Docket No. 50-336

Millstone Nuclear Power Station, Unit No. 2
ATWS Modifications (TAC #59114)

Attachment 1
Millstone Nuclear Power Station
Unit No. 2
Responses to Questions on
ATWS Modifications

FIGURE 1

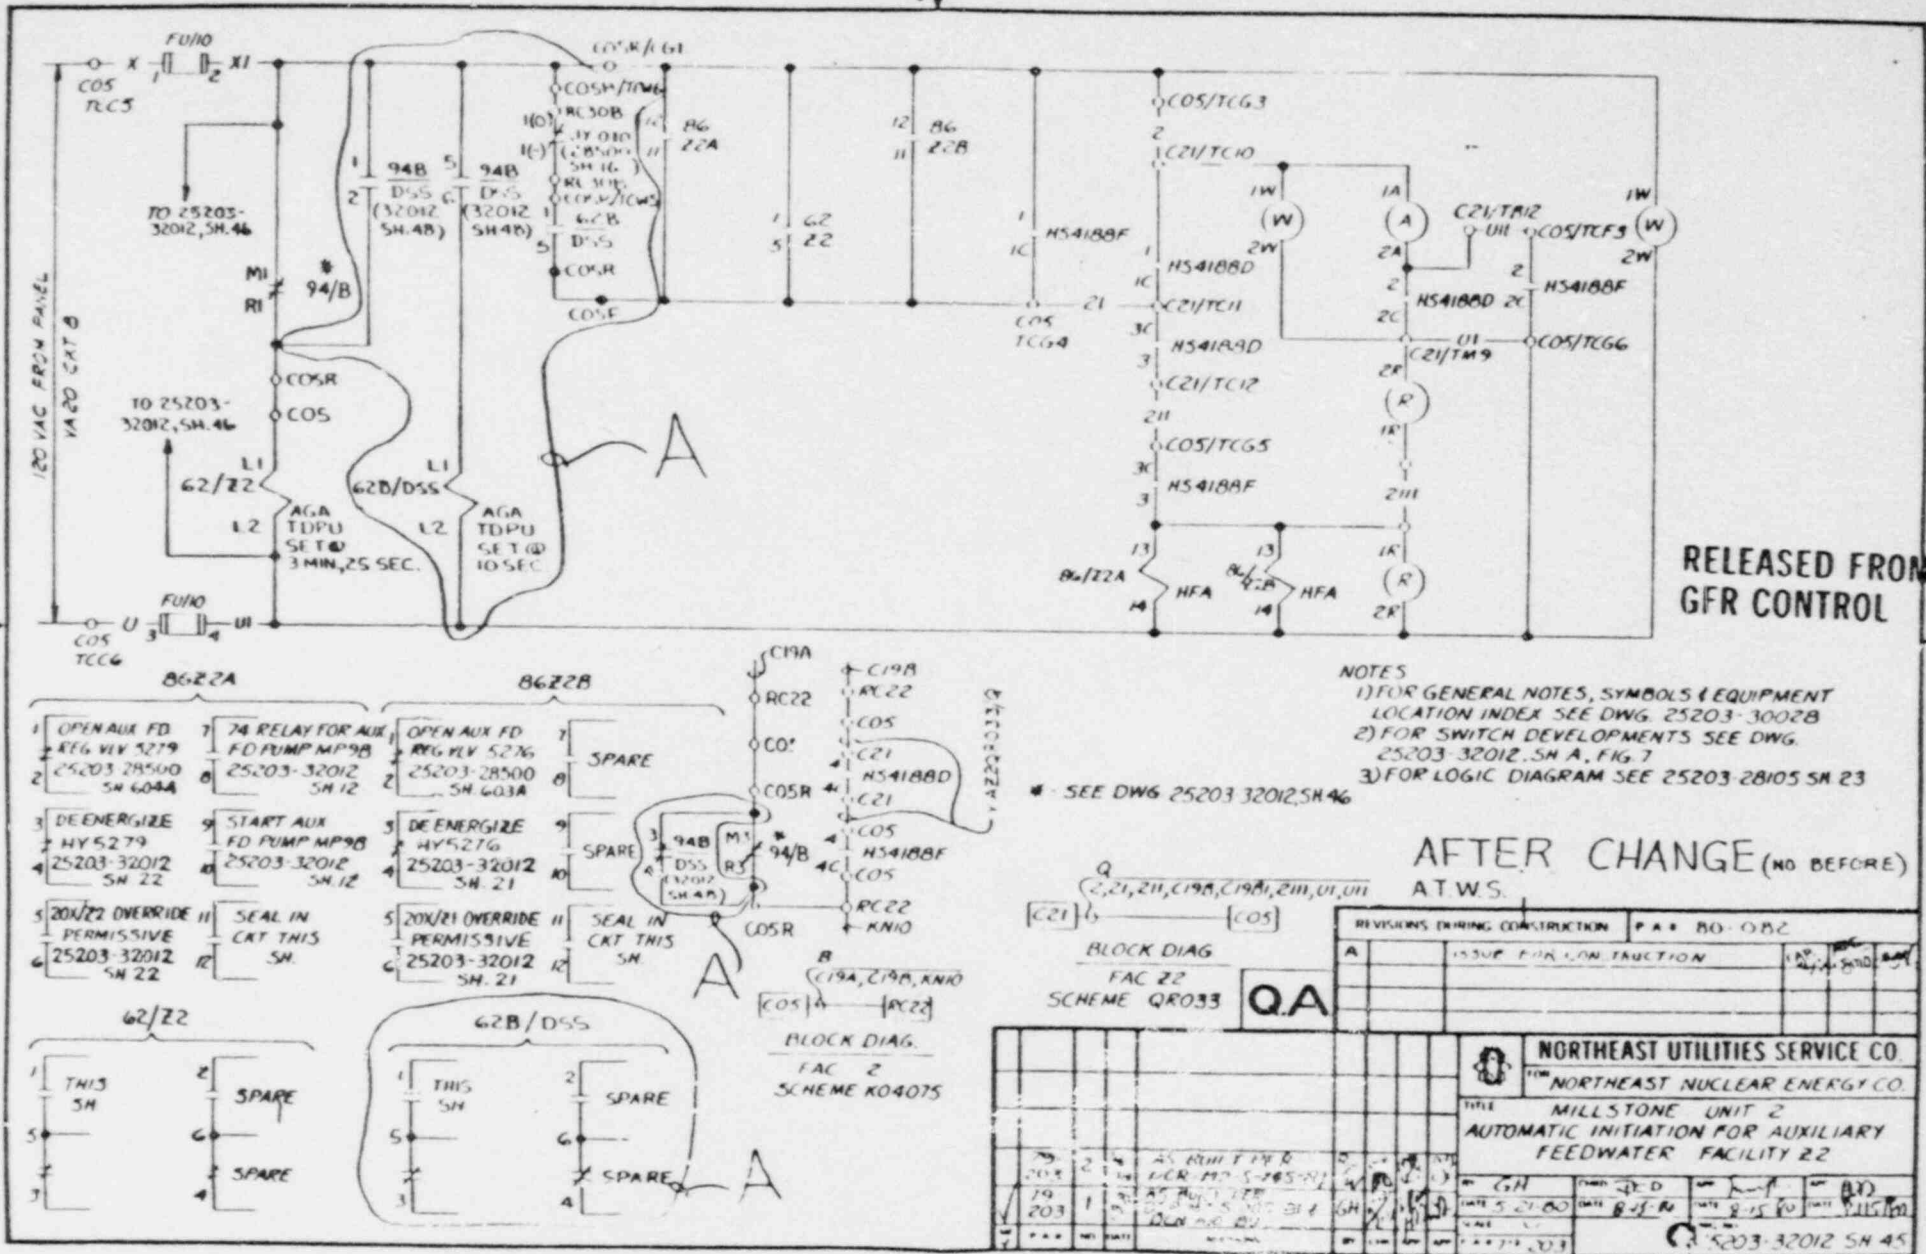
- b. Please provide electrical schematic/elementary diagrams for the DSS and DTT designs that clearly show all instrument channels (including bistables), logic, actuation circuits, test circuits, interlocks, bypass, alarms and indications. Also, provide electrical one-line diagrams showing the CEDM MG sets, DSS actuated output contactors, and power distribution to the RPS, AFWS, DSS and DTT circuits, including vital buses, inverters, batteries and chargers, etc.

- a. Although the ATWS mitigation is not required to be safety-related per 10CFR50.62, the DSS/AMSAC is designed to Category 1E in accordance with the NU Quality Assurance (QA) Program. All basic components for this design were procured to QA requirements for Cat. 1E equipment. The Cat. 1E components include the pressurizer pressure signal processing instruments (Foxboro SPEC 200 bistables and relay cards) and the time delay relays (Amerace Agastat E7012PD) in AMSAC.
- b. The following attached figures provide the highlight of system/elementary diagrams, electrical circuitry and schematics for the DSS/AMSAC design.

Figure 1: DSS/AMSAC System Block Diagram
Figure 2: Schematic Diagram for the DSS Trip and Bypass Matrix.
Figure 3: Elementary Connection Diagram of MG Sets With the DSS Trip Connectors.
Figure 4: Diverse AFWS (AMSAC) Modified From the Existing AFWS.
Figure 5: DTT Through the Under-Voltage (UV) Relay.
Figure 6: Power Supply (P.S.) of 125 VDC to DSS/AMSAC.
Figure 7: P.S. of 120 VAC to RPS.
Figure 8: Vital Buses of 120 VAC and 125 VDC.
- c. Will be answered with Questions 4 and 6 in the second response.
- d. As shows in Figures 2 & 6, the DSS/AMSAC is powered by 125 VDC from redundant vital 120 VAC buses, VA10 and VA20. The vital AC system is an uninterrupted power supply (UPS) from facilities battery through inverters and static switches as shown in Figure 8. Therefore, the DSS/AMSAC will remain fully operable to perform designed functions following loss of offsite power.

FIGURE 8 120 VAC 125 VDC

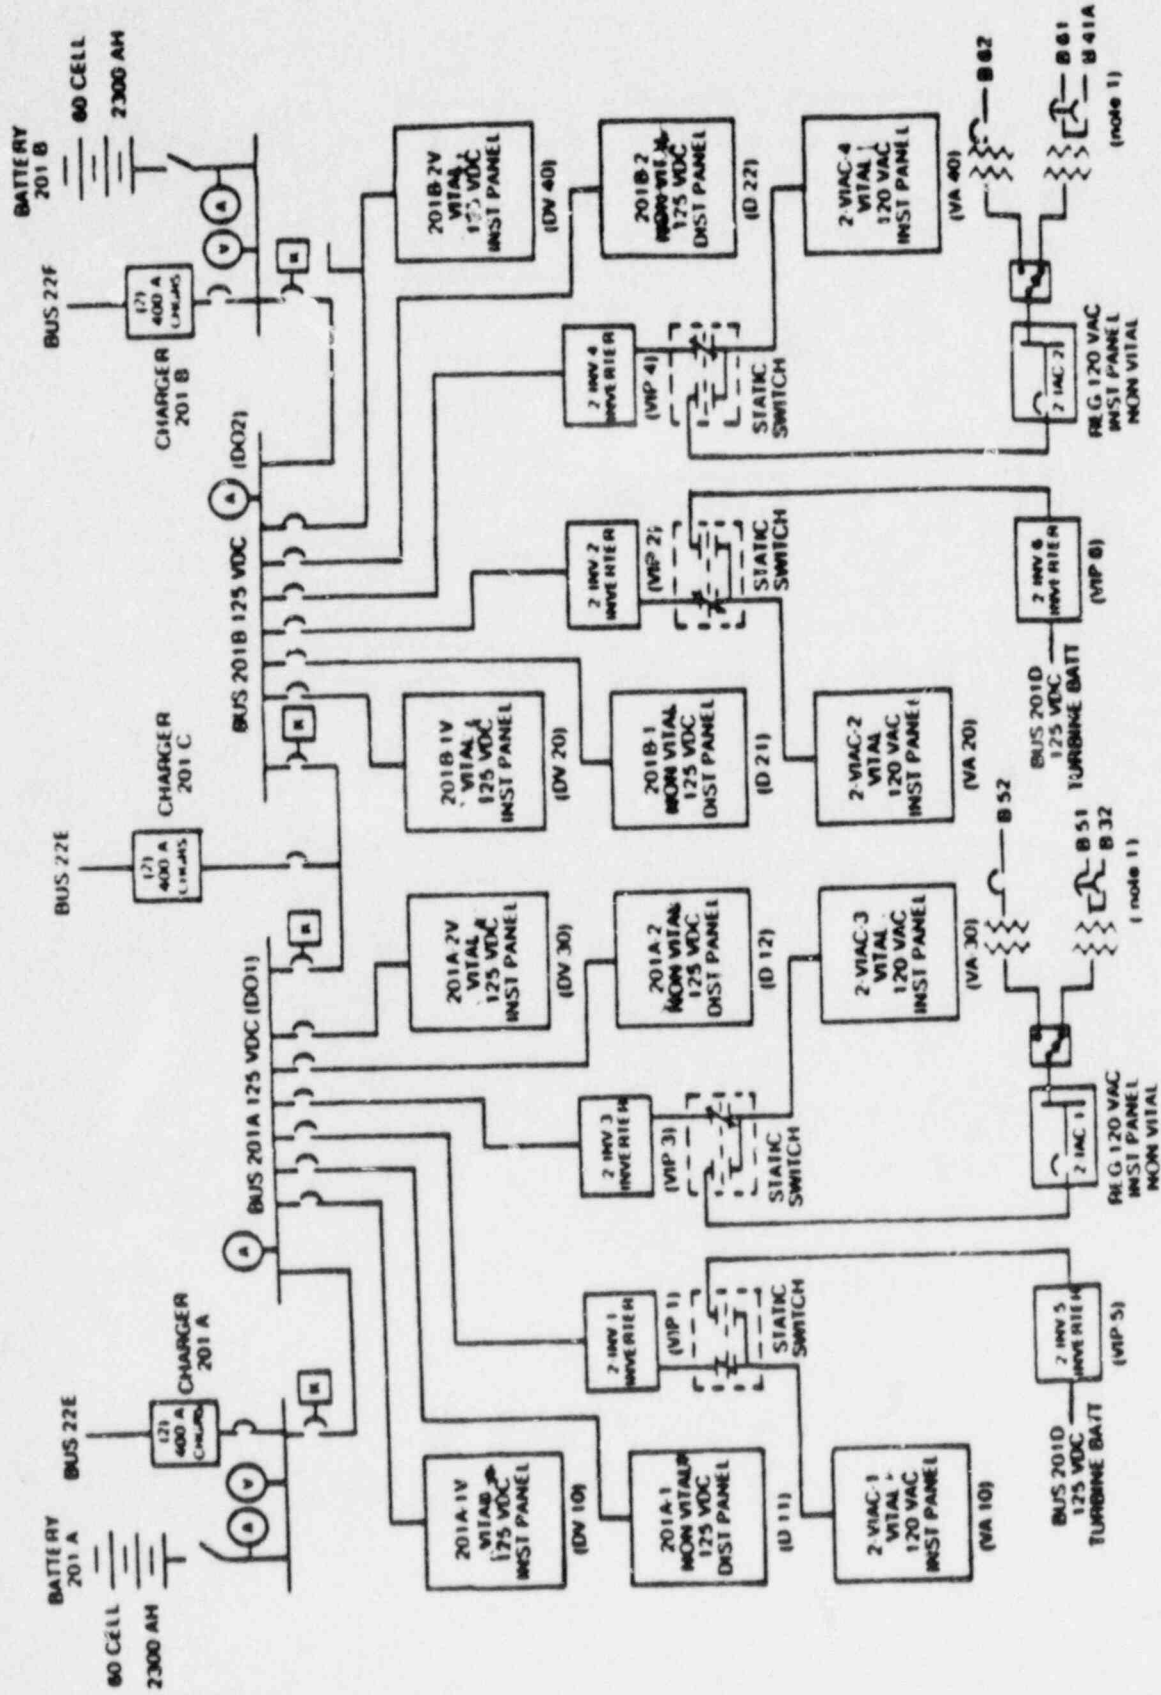
- d. Please provide information necessary to explain how the DSS and DTT will remain operable to perform their intended functions given a loss of offsite power.
- e. Please describe in detail the indications and alarms used to alert the control room operators to DSS and DTT inoperable conditions (e.g., when a channel/system or equipment is placed in a bypass or test status). Include a discussion of all operating and/or maintenance bypasses that will be used in conjunction with the DSS or DTT.
- f. Explain the specific operator actions required to manually initiate a DSS and/or DTT protective action. Also, following manual or automatic initiation, is the protective action sealed in at the system level to ensure completion of the ATWS prevention/mitigation function?
